The
WHITE PINE
SERIES OF
Architectural Monographs
Volume VII **Number 4**

Designs for a
THREE TEACHER
RURAL SCHOOL
With Teachers' Cottage

A THREE-TEACHER RURAL SCHOOL WITH TEACHERS' COTTAGE

REPORT OF THE JURY OF AWARD OF THE SIXTH ANNUAL WHITE PINE ARCHITECTURAL COMPETITION

FIRST MENTION, Detail Sheet
Submitted by Alfred Cookman Cass, New York, N. Y.

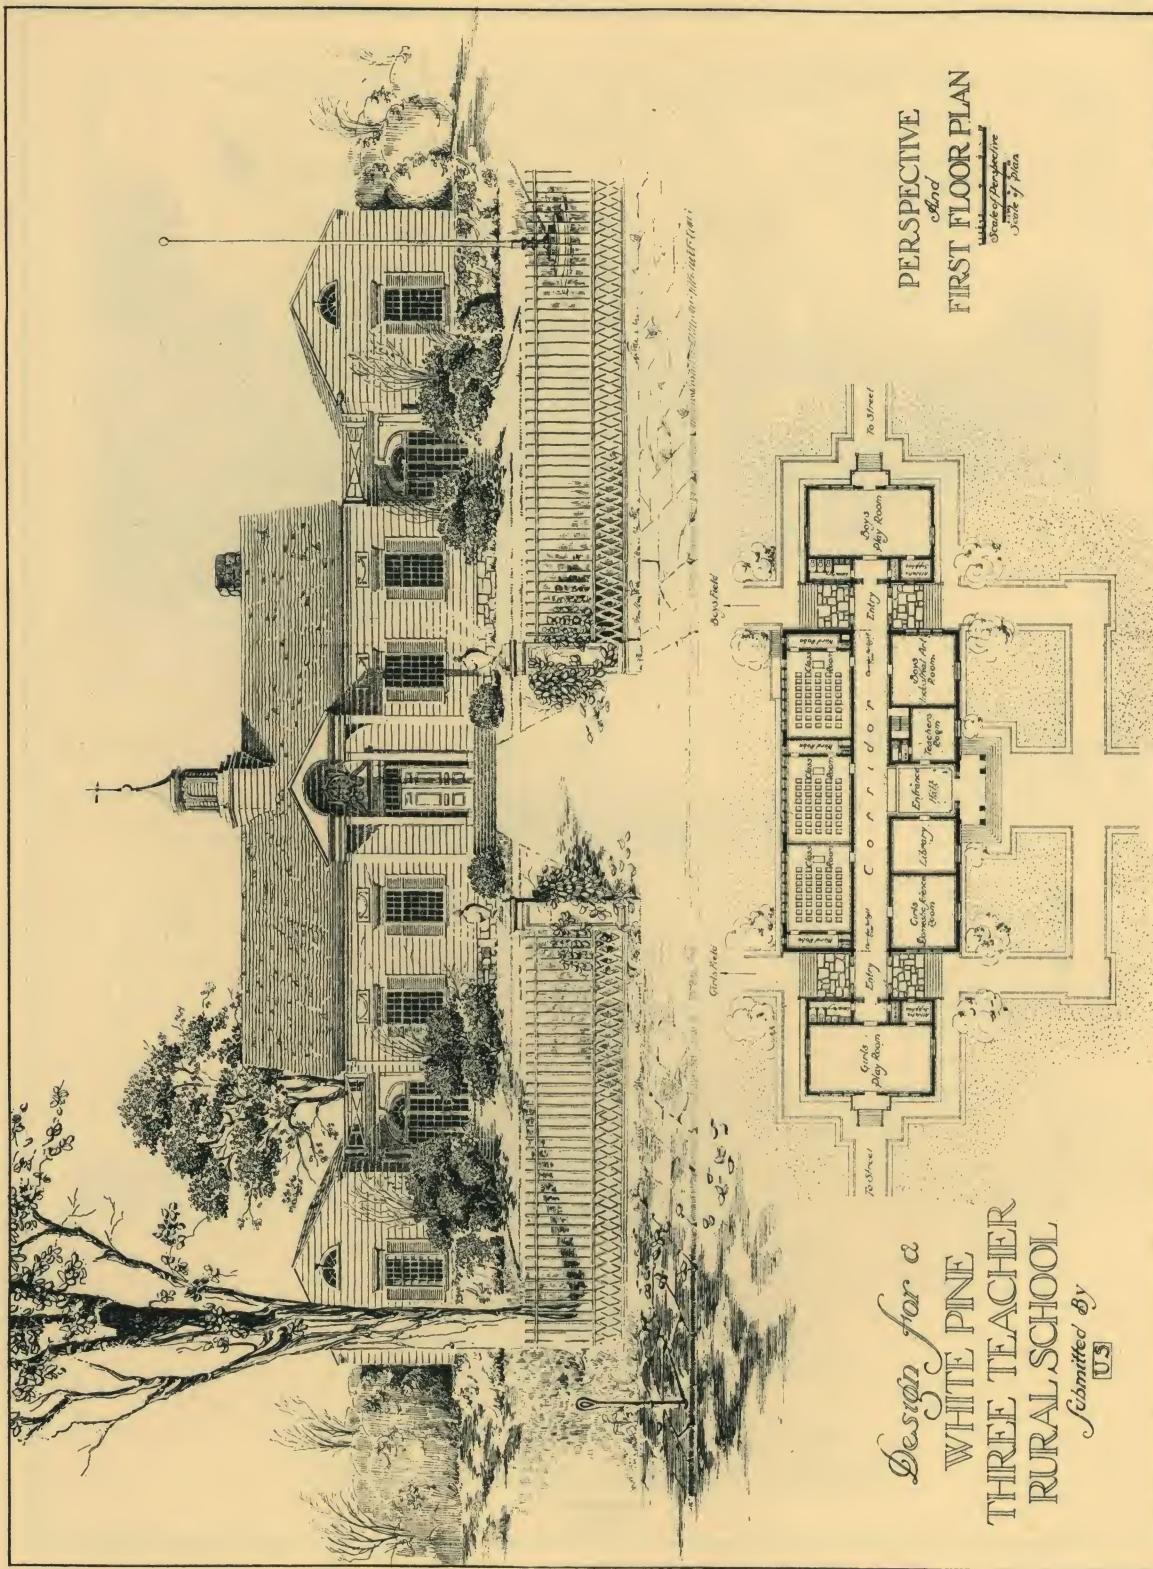
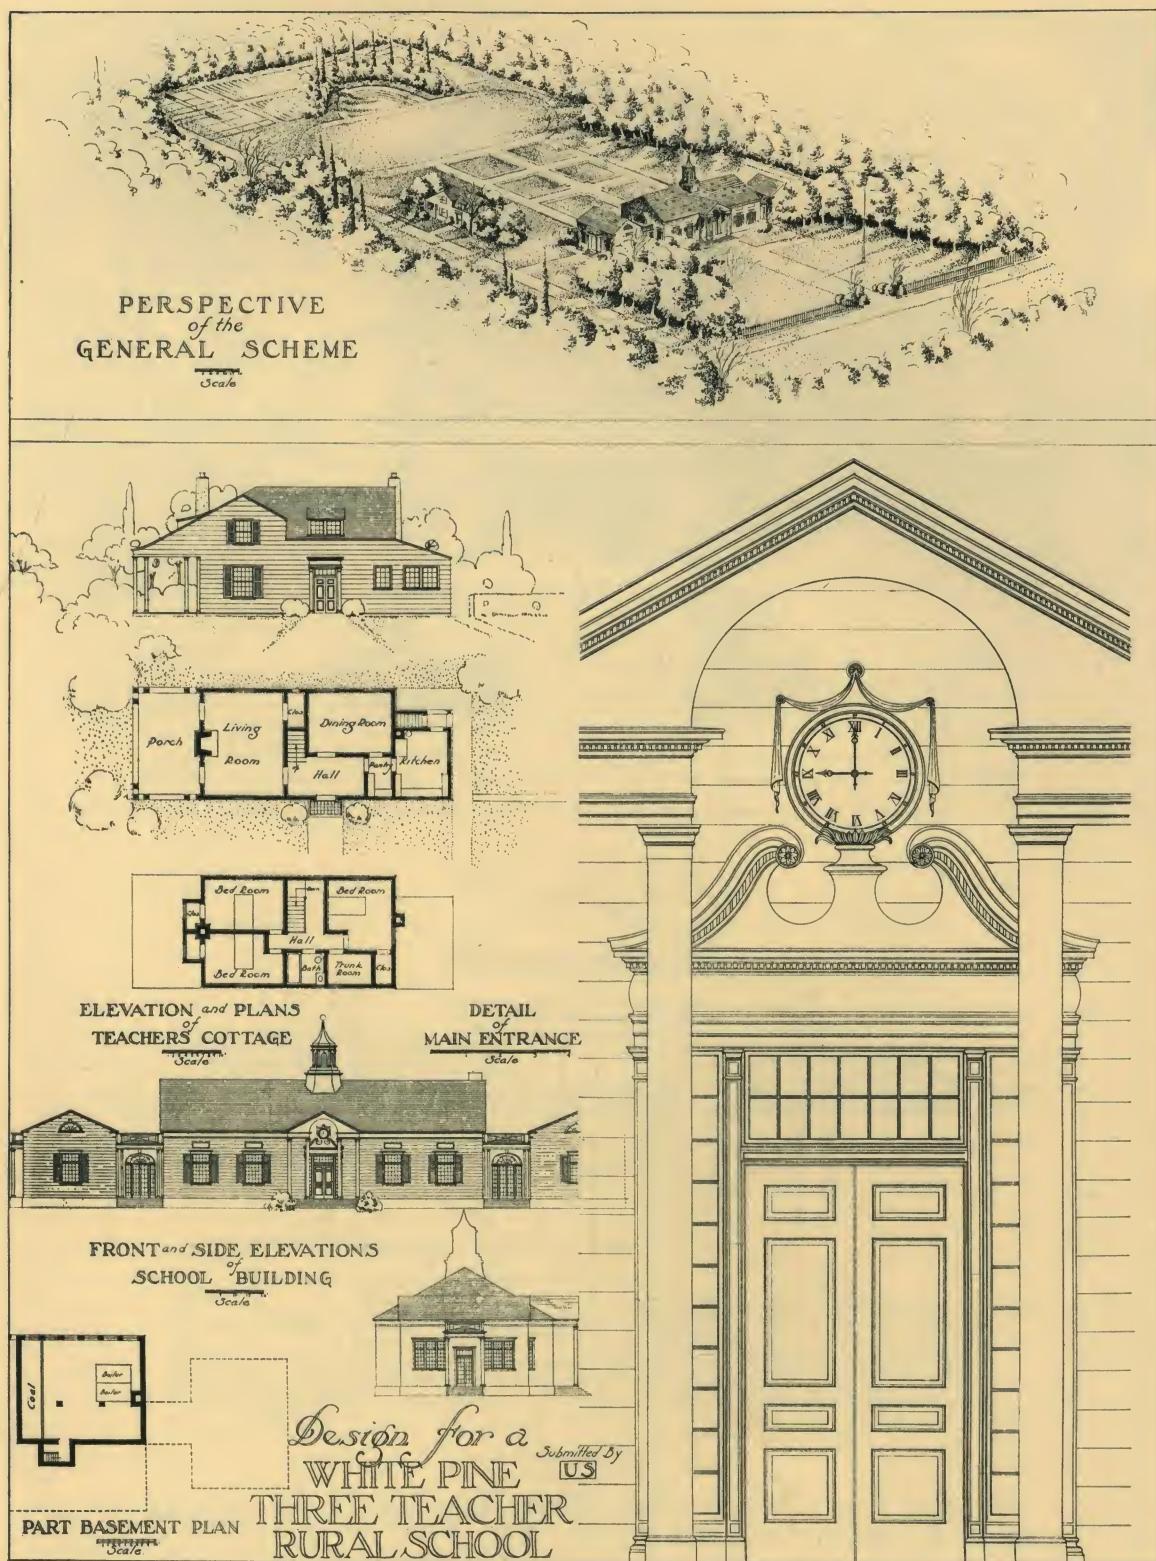
SECOND MENTION. Submitted by David W. Carlson and Emil A. Lehti, of New York, N. Y. Of the designs to receive Mention, of which there were six, two seemed worthy of being given a definite place, and the Jury takes pleasure in according them this recognition. The First Mention is quite "academic" in design, that is, suggestive of the old "academies," yet rural in character; while the Second Mention has a decidedly free and picturesque quality. The interior toilet in connection with the teachers' room in this design is a blemish in the plan which a bit of practical surgery might remove. The setting of the "academic" design is attractive.

MENTION, Detail Sheet

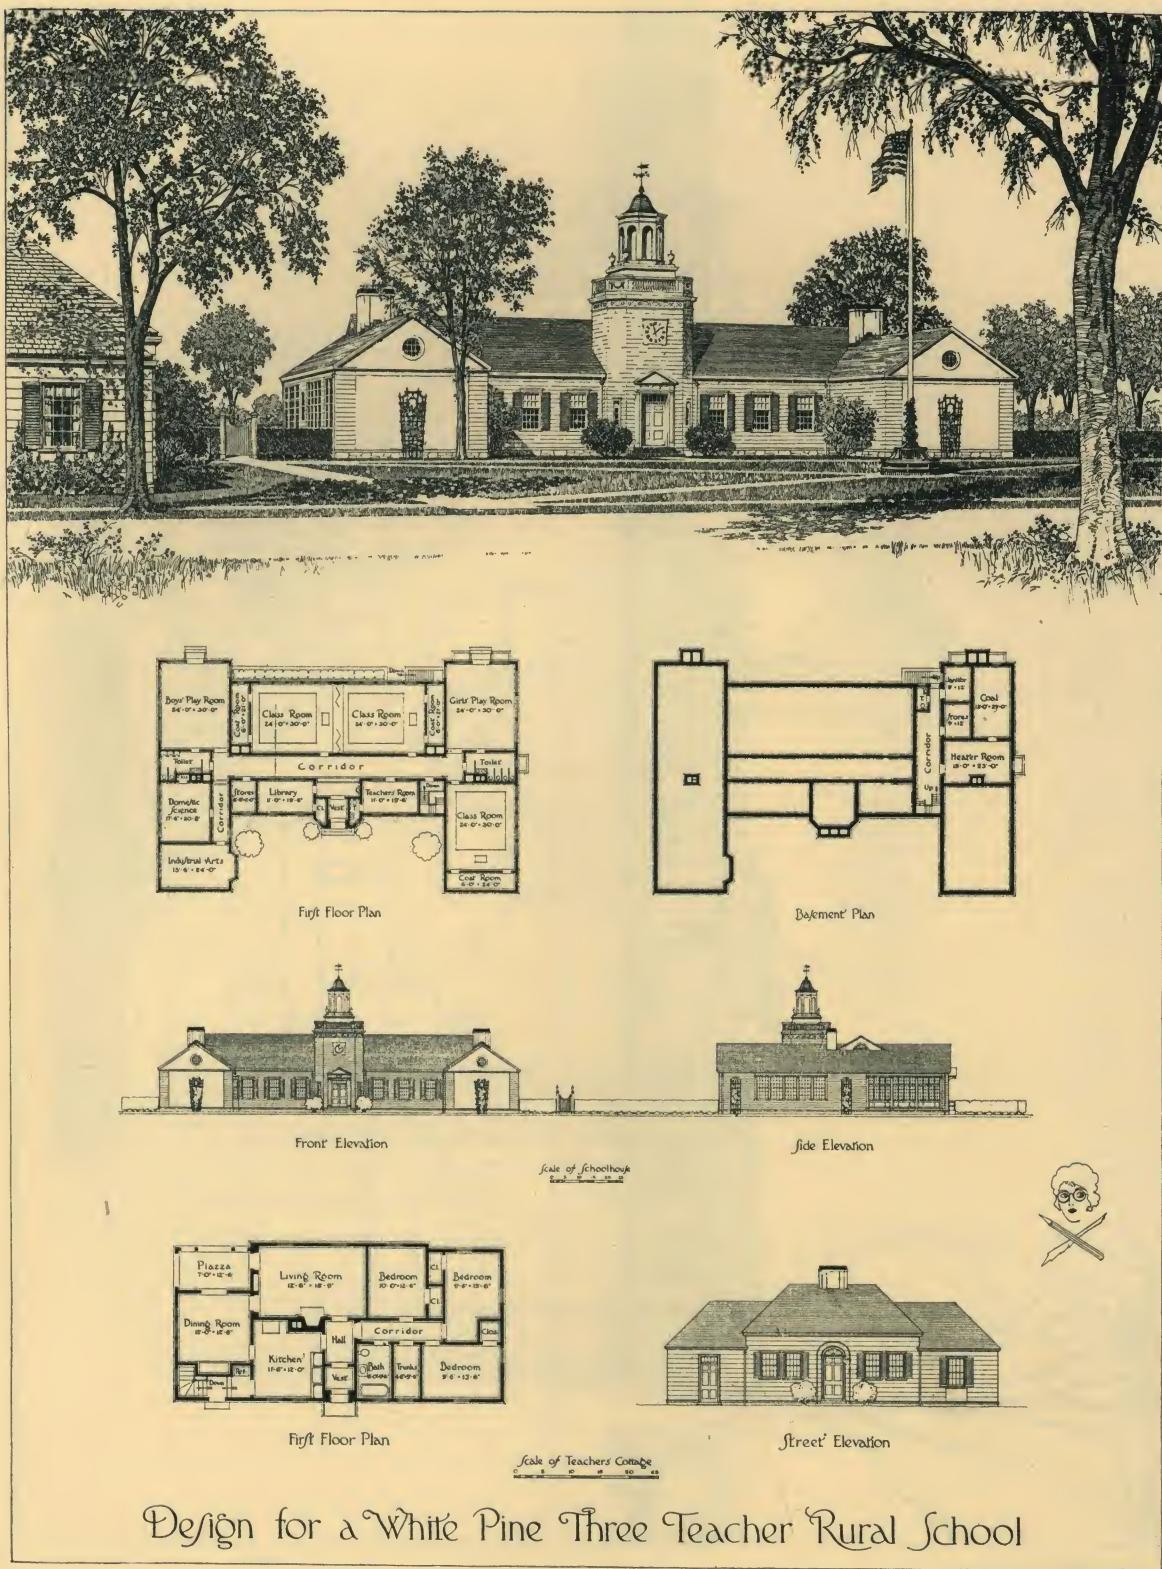
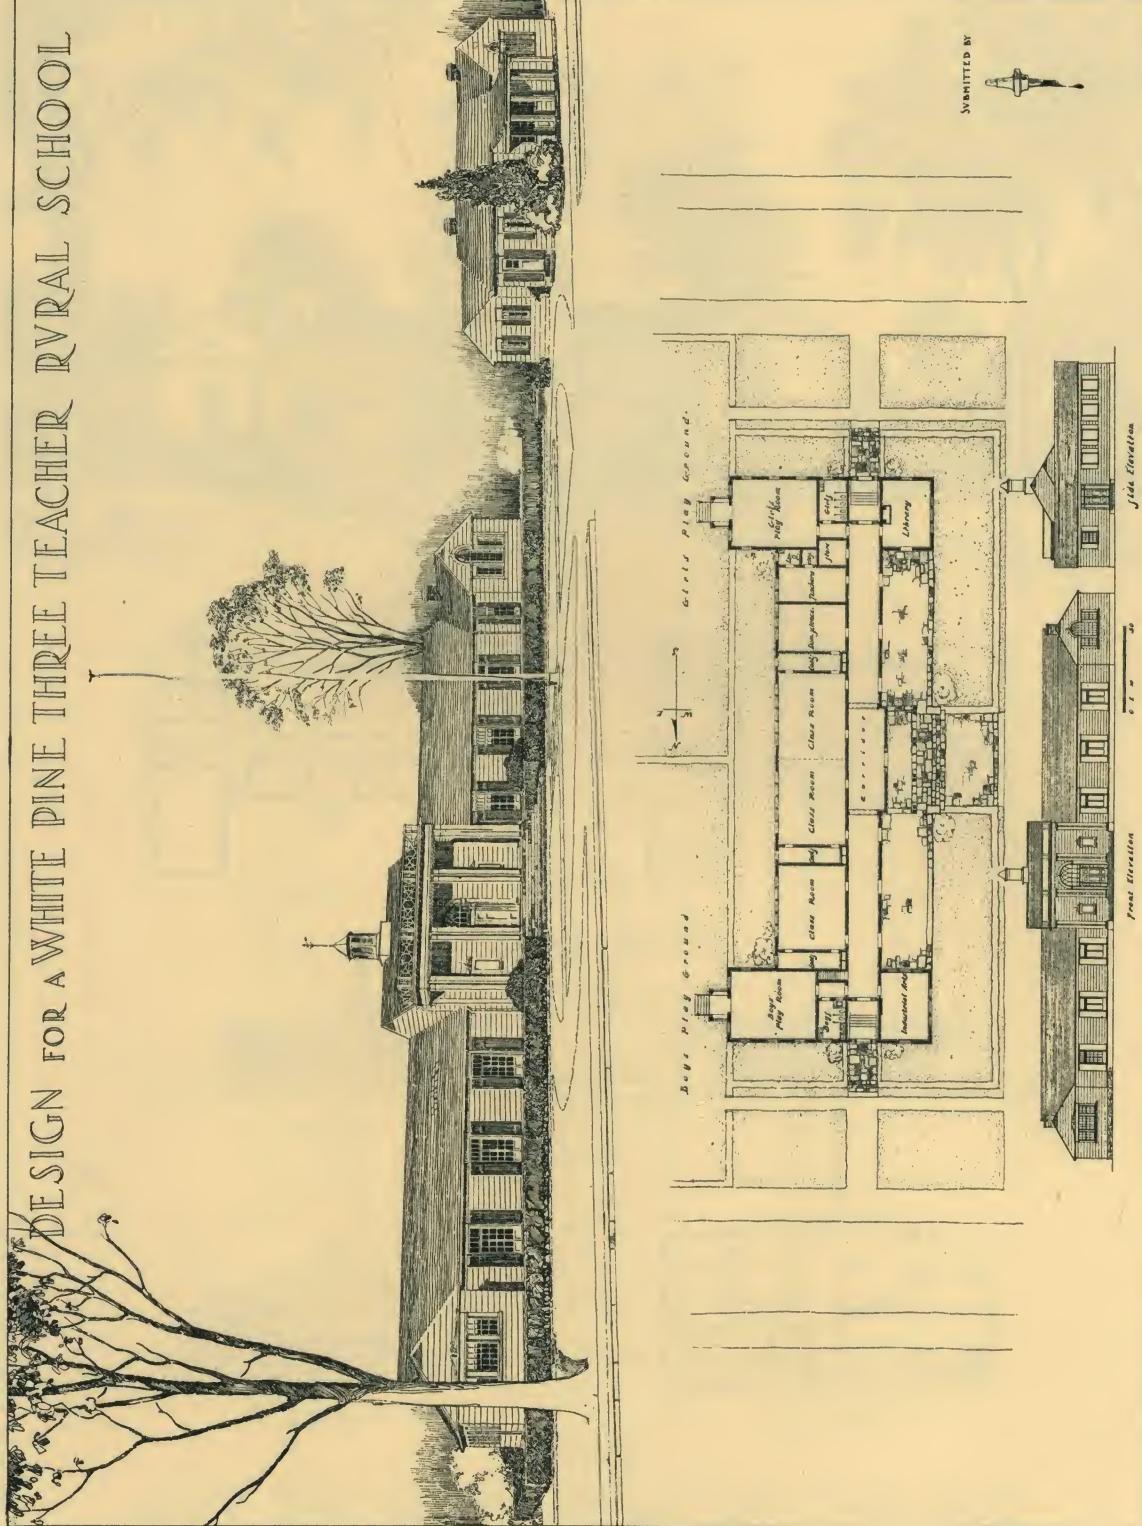
The design submitted by Messrs. Mooney and Rich was the simplest and most appropriate of the designs which featured a tower, of which there were six in the competition. The plan is compact and well arranged, its principal weakness, except for the cramped vestibule, lying in the dark corridor terminating in the toilet rooms rather than in points of light. An otherwise dark corridor may be saved and even made attractive by opening up the ends to the light.

Submitted by Charles H. Dornbusch and Erick N. Kaeyer, New York, N.Y.

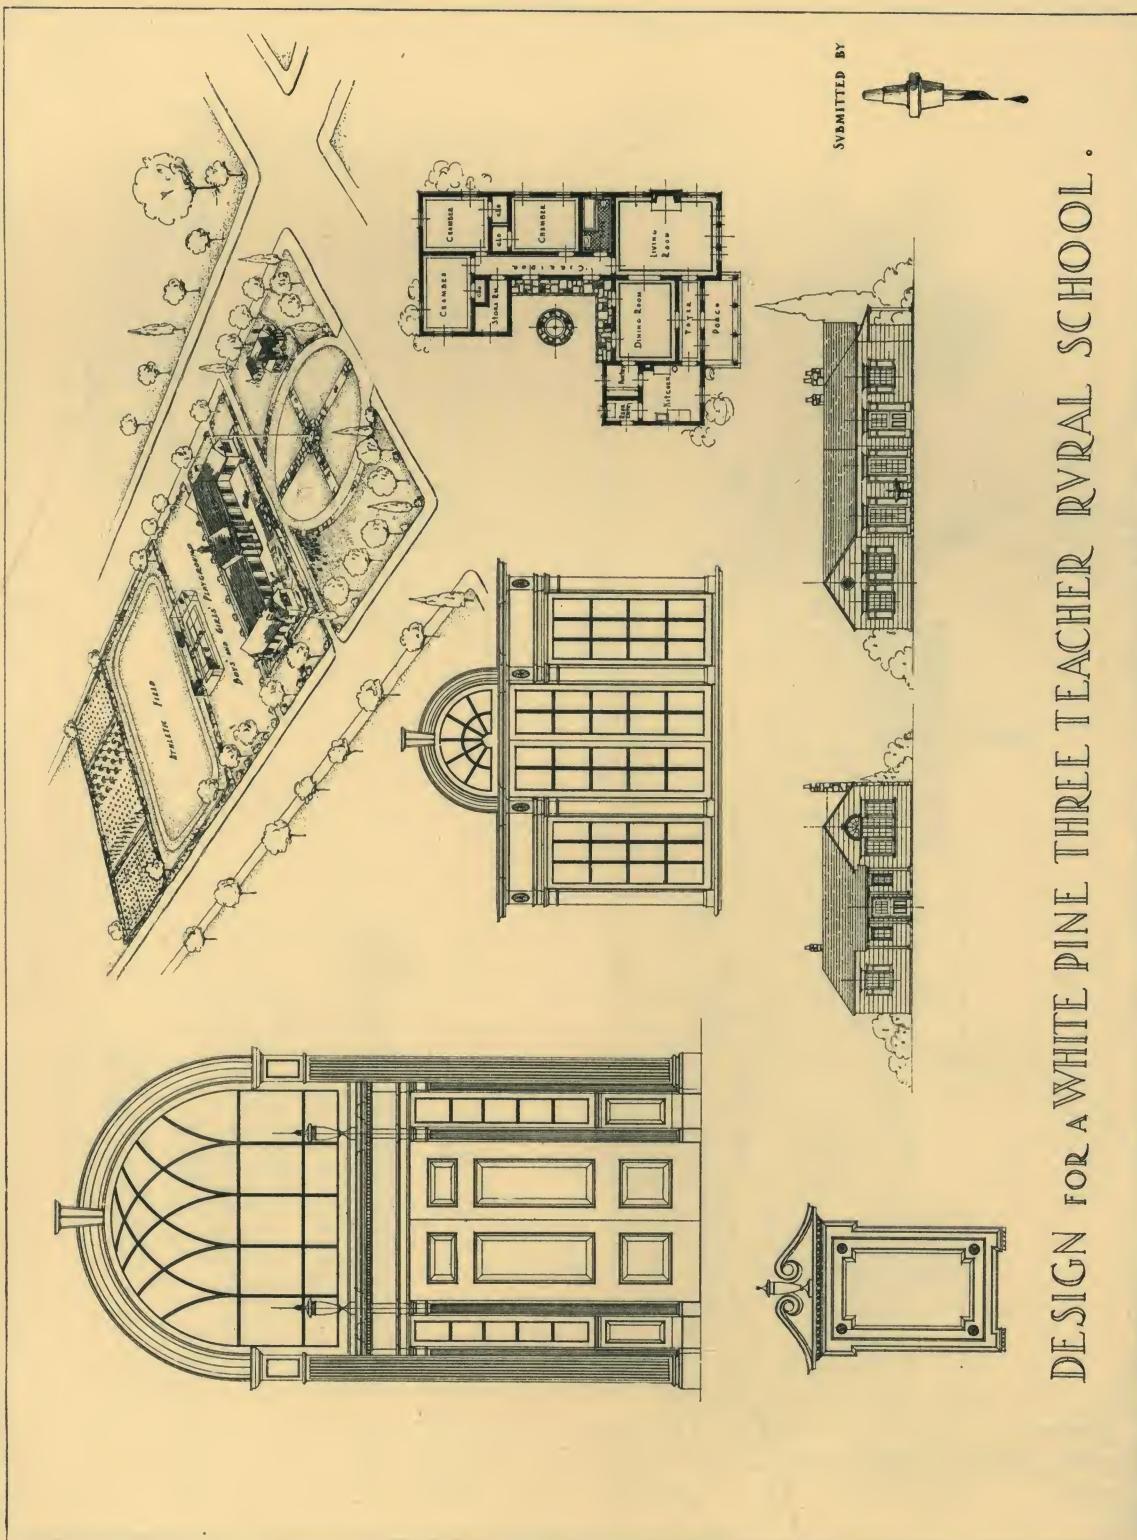
The design submitted by Messrs. Dornbusch and Kaeyer, while extremely attractive in its terraced approaches, suffers from a lack of relationship between the wings, and a central feature which is attenuated and inadequate. The corridor is satisfying. Mr. Harbach's design is good of its type, with a well considered plan, and an
